Committee of Experts on the Transport of Dangerous Goods  
and on the Globally Harmonized System of Classification  
and Labelling of Chemicals

**Transport requirements for ultracapacitors (Electric Double Layer Capacitors)**

**Transmitted by the Kilo Farad International (kFI)**

**Response to comments on informal document INF.68**

Figure 1 – For Reference; Comparison of Approximate Free Liquid Mass to Energy Storage Capacity

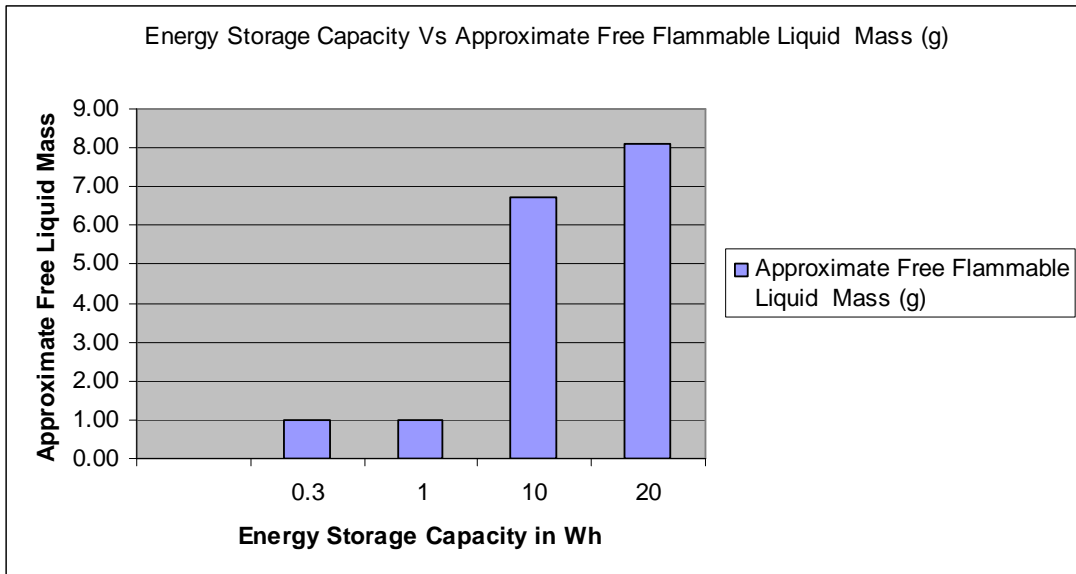
1. Summary of comments: See attached
2. Information on flammable liquid amounts according to Wh rating: See attached
3. Based on Subcommittee discussions on Inf 68 the Subcommittee is asked to decide:
  - (a) Whether the threshold limit for EDLCs that should be fully regulated as class 9 dangerous goods should be 10 Wh or 20 Wh.
  - (b) Whether EDLCs subject to limited requirements (i.e., equal to or less than 10Wh or 20 Wh depending on the decision above) should be subject to:
    - (i) A drop test from a height of 1.2 m as **packaged for transport** in any orientation without loss of contents; or
    - (ii) A drop test from a height of 1.2 m **unpacked** without loss of contents.
  - (c) Whether to mark “nominal capacitance and voltage” in place of the “energy storage capacitance in Wh” in proposed SP AAA(d). Note:  $Wh = [1/2 CV^2 ]/3600$
